PCN# 20150824000

**Qualification of CFAB as an additional wafer fab site option for select devices in the
LBC5 process technology
Change Notification / Sample Request**

Date: 8/26/2015
To: MOUSER PCN

Sample product shipping label (not actual product label)

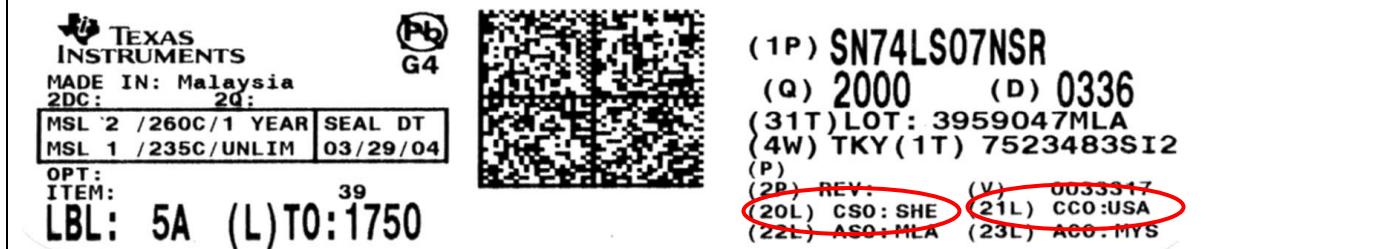
Changes to product identification resulting from this PCN:

Current

Chip Sites	Chip Site Origin Code (20L)	Chip Site Country Code (21L)	Chip Site City
DP1DM5	DM5	USA	Dallas

New

Chip Site	Chip Site Origin Code (20L)	Chip Site Country Code (21L)	Chip Site City
CFAB	CU3	CHN	Chengdu
